GEOLOGICAL INVESTIGATION OF THE ROUTE OF THE KAINANTU-GOROKA ROAD,
NEW GUINEA, APRIL 1966.

J.R.L. Read.

Records 1966/161

An investigation to confirm the geological feasibility of the Kainantu - Goroka road, Territory of New Guinea, was carried out in April 1966.

fig 1

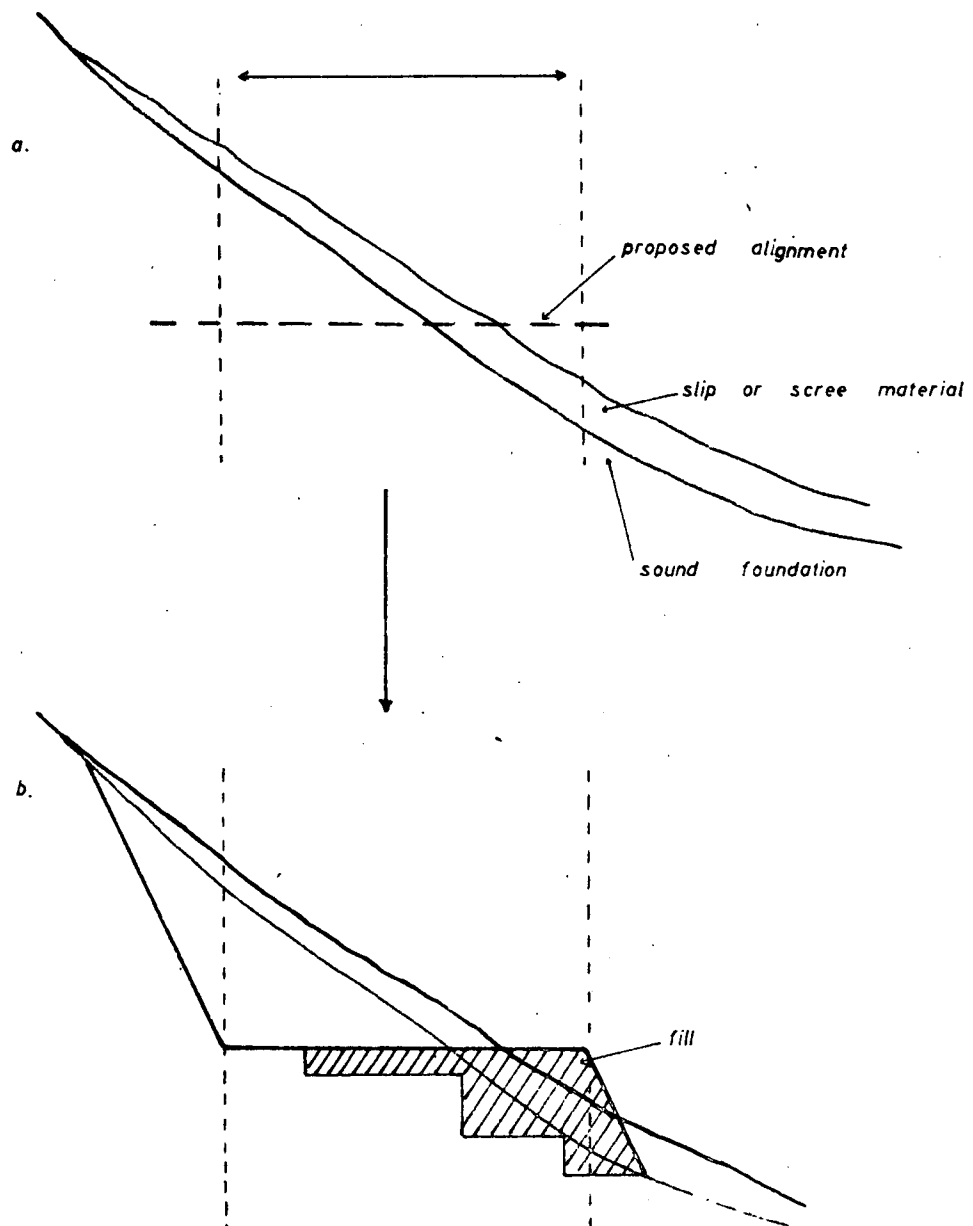
A. Side-cut and box-cut embankments should not exceed a vertical height of 20 feet, nor have a slope steeper than $1\frac{1}{2}:1$. Embankments in cuts 20 feet or more deep should be benched; the width of the berms so formed should not be less than 10 feet. Where a cross-slope is steeper than that recommended for the slope of the embankment the angle of the cross-slope should be reduced. These recommendations are aimed at preventing two types of failure:

(i) failure of the ground above the cut due to removal of support from the toe of the slope in the cut. This type of failure is the dominant cause of landslides along the existing and proposed roads. In nearly all cases there is a definite interface between overburden and firm ground; in some cases this interface corresponds to outward dipping relic bedding, and in nearly all instances is aligned roughly parallel to the surface topography. With the removal of support and, in the wet season, entry of water into the overburden and along the interface, failure occurs, and the overburden slides over the firm ground.

(ii) embankment failure. The strength of the residual clays along the alignment - resulting from cohesion and internal friction - rapidly tends towards zero when the mass becomes saturated. It can be observed that few embankments along the existing road which have a vertical height in excess of 20 feet maintain stability for long in the wet season. Any increase in the vertical height, or the slope, of an embankment over twenty feet should be made only if favourable results are obtained from

from tri-axial tests on undisturbed samples from the site. Consideration must also be given to the influence of local geological structures.

fig 2

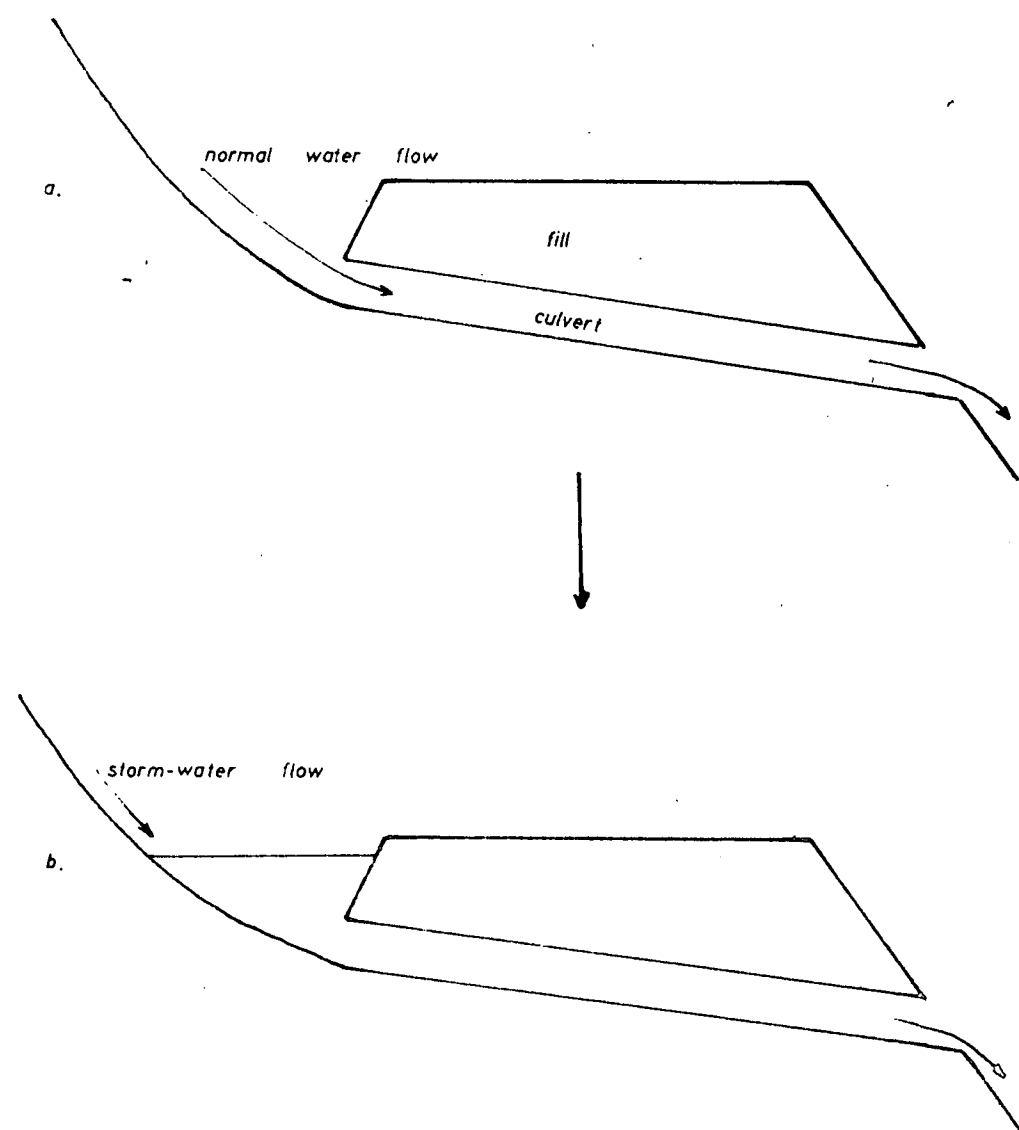
Culverts should be designed so that storm-water run-off can be cleared as rapidly as possible. The contract design for culverts allows for a time lag such that it is possible for a head of water to build up behind the culvert (fig. 2). This increases the likelihood of the culvert becoming blocked and introduces a seepage of water into the fill. Piping, leading to the eventual failure of the fill could result, particularly if compaction of the fill during construction had not been adequate.

It will be difficult to maintain stability between 216,931 (220,000), and the culvert site at 212,000. Slopes in this section are steep and clearly unstable, and the removal of support from the slopes by the cutting of batters will increase the danger of landslides. All batters will have to be benched and particular care will have to be taken to ensure that fill material is placed on firm ground - benching of the foundation will probably be required. Drainage provisions will need to be adequate and it is recommended that all culverts in the section have a minimum diameter of 36 inches (as against the 18 inches specified in the

design). It is essential that all storm-water run-off be removed from embankments and pavement as rapidly as possible and is not permitted to soak into or erode fill material.
